Tesoro Refining & Marketing Company LLC

November 23, 2021

RE: Tesoro Refining & Marketing Company LLC's Comments on Washington's Regional Haze State Implementation Plan Revision: Second Regional Haze Plan (2018 – 2028)

Figure 1 Components included in the EPA Cost Model Shown in Yellow. Components not included in the EPA Cost Model shown in Blue

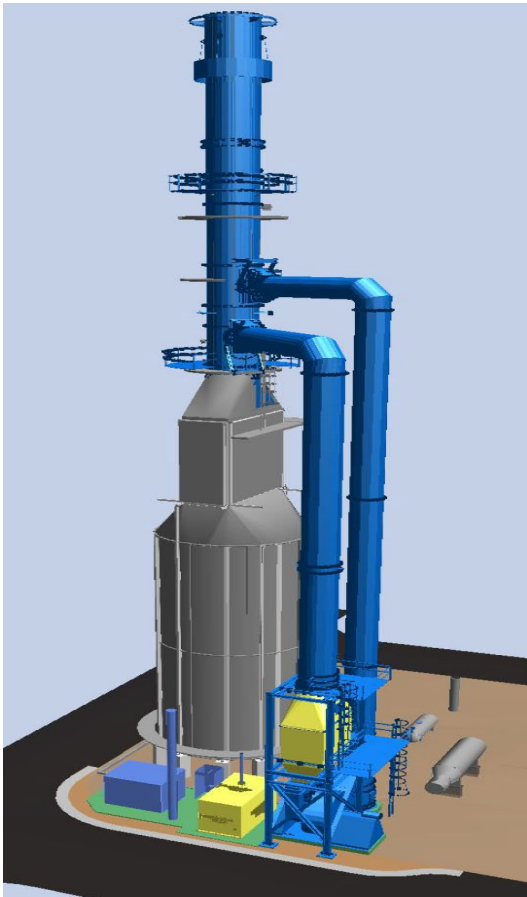
Cost-effectiveness determinations must also include all the costs to install and operate the SCR, not just the costs of the SCR itself. Additional scope items not included in the EPA SCR Control Cost Model that need to be included are ancillary costs such as electrical infrastructure modifications, stack modifications, installation of new fans, installation of new convection sections required to operate the SCR at the required temperature, ammonia piping, and other costs associated with operating the control equipment.

Figure 1 shows in yellow the equipment included in the EPA SCR Control Cost Model and shows in blue the ancillary equipment necessary for operation that is not included in EPA’s SCR Control Cost Model.

The EPA SCR Cost Model inappropriately excludes the following ancillary equipment that are required to be installed for proper SCR operation at a typical heater or boiler:

- induced draft fan;
- exhaust stack;
- electrical infrastructure;
- convection section;
- ductwork;
- foundations;
- instrumentation;
- ammonia supply piping; and
- civil and structural steel supports.

Therefore, Ecology should revise its draft RH SIP and consider in any future reasonableness assessment the real expected costs for retrofitting equipment, including the ancillary equipment costs required to operate SCR.

Figure 2 MPC's and Ecology's SCR Total Capital Costs Overlaid with Figure B-4 of the SCAQMD Rule 1109.1 Staff Report

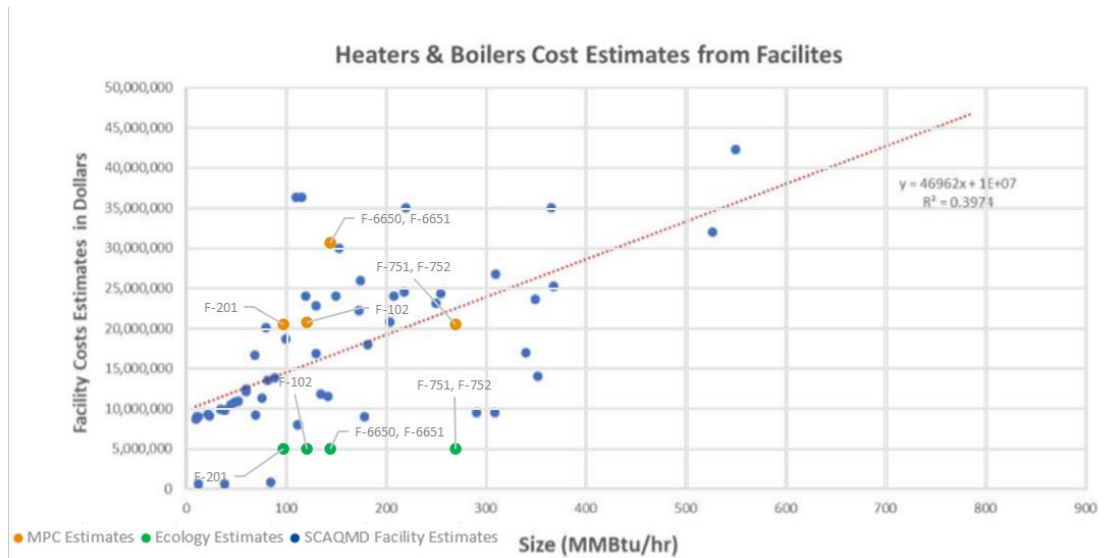
When conducting its cost calculations for the RH SIP and any future reasonableness assessments, Ecology should refer to SCAQMD's equipment cost estimating method and cost-effective calculations it performed when developing the recently adopted Rule 1109.1 - *Emissions of Oxides of Nitrogen from Petroleum Refineries and Related Operations*.⁴ While Rule 1109.1 was driven by the severe ozone nonattainment status in the South Coast air basin in California, which is a more significant regulatory driver, the supporting control cost evaluation is nevertheless informative. In summary, to reflect the actual total installation costs (TIC) for an SCR installation in the refinery sector, SCAQMD staff modified the EPA SCR cost spreadsheet using actual TIC estimates provided by the facilities. EPA approved and endorsed the revised methodology to reflect the change for the refinery sector.⁵ For Ecology's reference, in Figure 2 below, we have overlaid

MPC's estimates (shown as orange dots) and Ecology's estimates (shown as green dots) on top of SCAQMD's distribution of estimated costs based on equipment size.⁶ As Figure 2 demonstrates, MPC's costs are consistent with SCAQMD's cost estimates, while Ecology's estimates fall well below the linear regression line of the data used by SCAQMD.

Importantly, SCAQMD ultimately acknowledged the limitations of the EPA Cost Model and developed their estimates of total capital costs for installation of SCR by considering actual facility costs of installation that were submitted by refineries, which were reviewed by third-party engineering firms (i.e., FERCo and Norton Engineering). SCAQMD even stated in its rulemaking Draft Staff Report that the “Total Installation Cost (TIC) for SCR installations in the refining sector can be up to 10 times more expensive due to the limited space within processing units; some facilities have performed elaborate SCR engineering designs to install their SCRs. As a result of space and engineering requirements, TIC cost that a refinery incurs increases significantly compared to the electric power generating sector.”⁷ To support its cost-effectiveness calculations for the RH SIP, Ecology should consider the approach used by SCAQMD for its Rule 1109.1. In doing so, Ecology should also incorporate the costs MPC provided in its 2020 FFA Report into the cost-effectiveness calculations in the RH SIP and any future reasonableness assessment.

Figure 3 Contributions to Light Extinction Between 2014 and 2018 on the most impacted days¹⁴

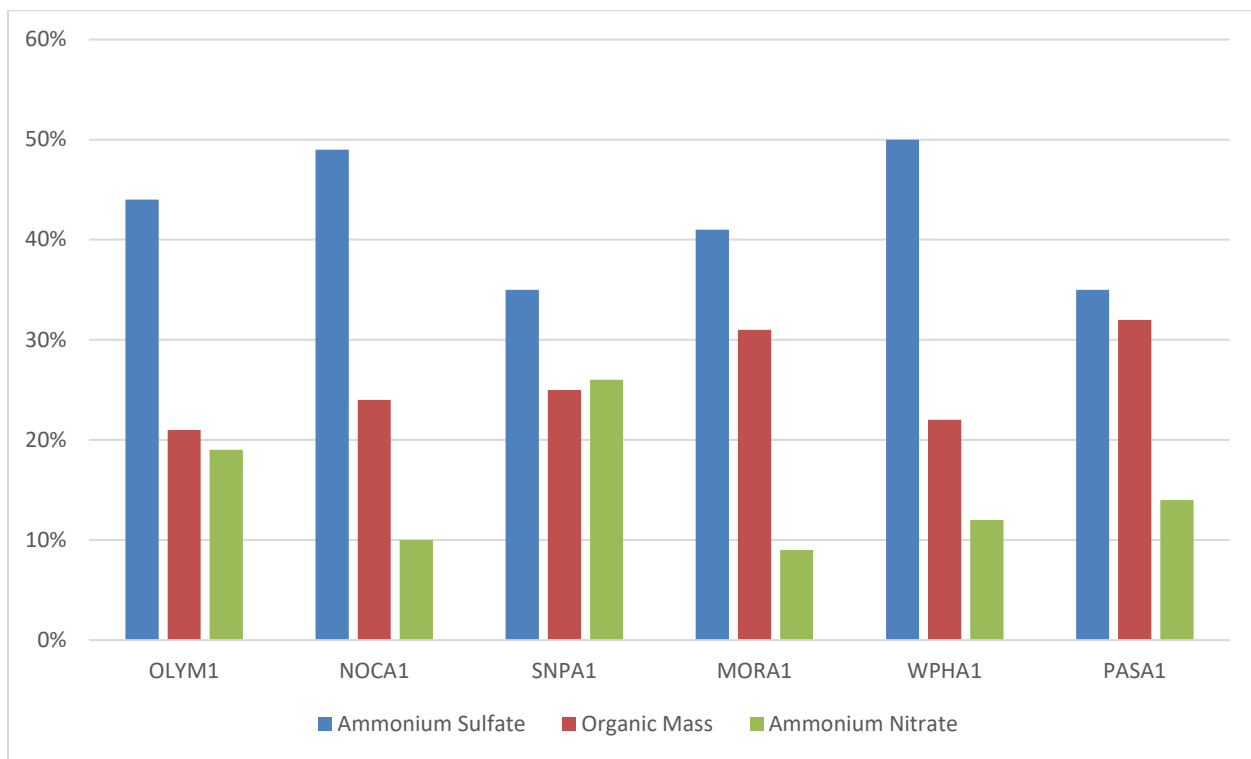
The draft RH SIP language overstates the impact of refinery emissions on RH. The data presented in the draft RH SIP demonstrates that nitrates are not the primary contributor to light extinction in Washington's Class I areas. Both ammonium sulfates and organic mass contribute more to light extinction overall than ammonium nitrates. As such, required NO_x reductions at refineries would have minimal impact on visibility improvements. Figure 5 summarizes the average contributions to light extinction for ammonium sulfates, organic mass, and ammonium nitrates between 2014 and 2018 based on the tables in the draft RH SIP.

Figure 4 Summary of Draft RH SIP's Representation of NO_x Emissions in Representative Baseline Year

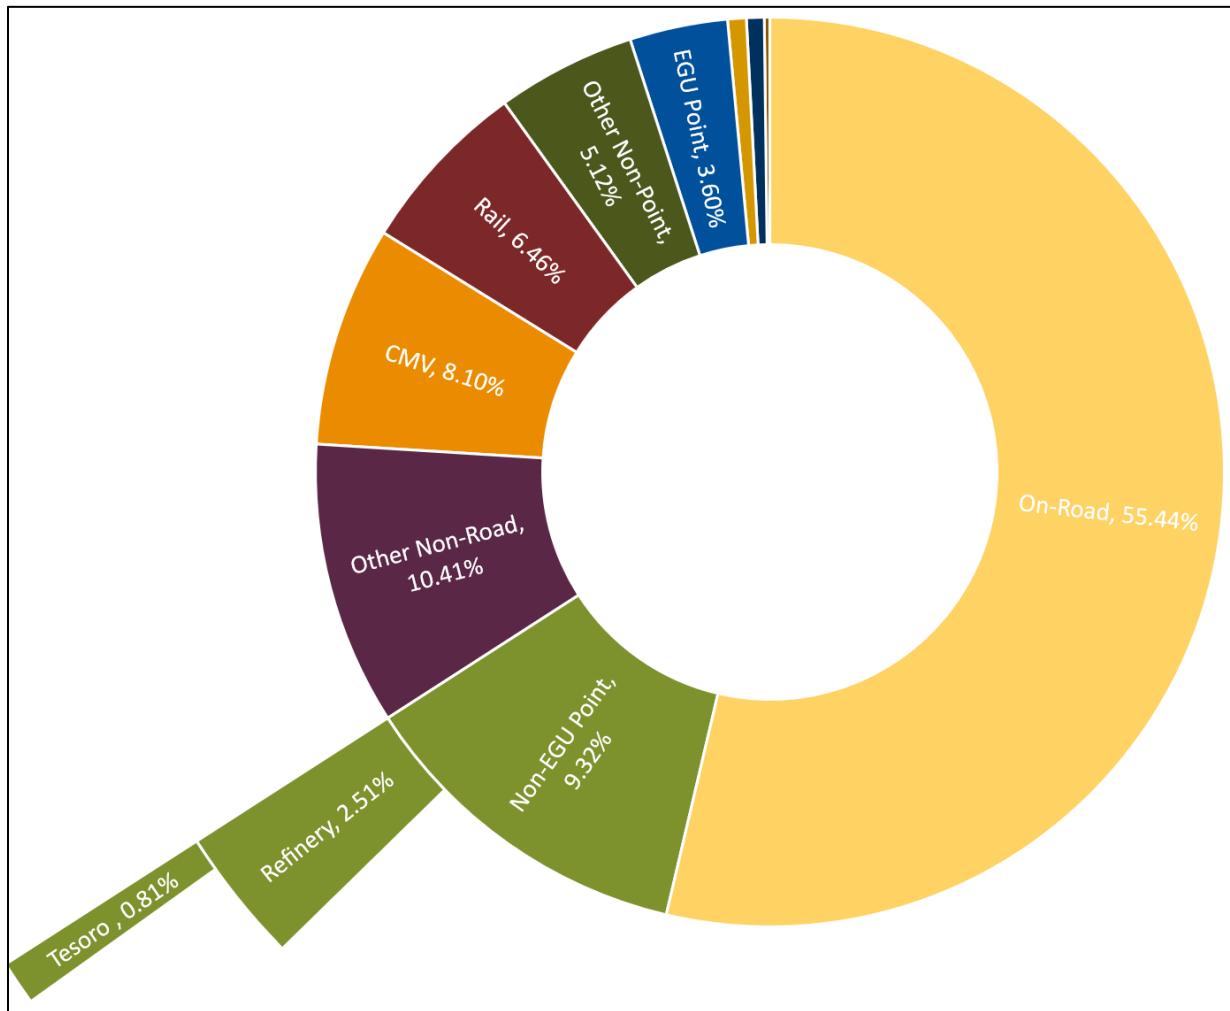
Additionally, refinery impacts on NO_x emissions are overstated in the draft RH SIP. Figure 6 summarizes Ecology's representations of NO_x emissions for the representative baseline year in the draft RH SIP.

Non-electrical generating unit (non-EGU) point sources, refineries, and MPC's Anacortes Refinery account for only 9.3%, 2.5%, and 0.8% of the NO_x emissions in the representative baseline year, respectively. Refinery NO_x emissions represent a small portion of the state emission inventory and are a minor contributor to light extinction. Focusing mainly on NO_x controls at refineries is not reasonable based on the minimum impact it would have on visibility, and modeling future cases already indicates results below the adjusted glide path.
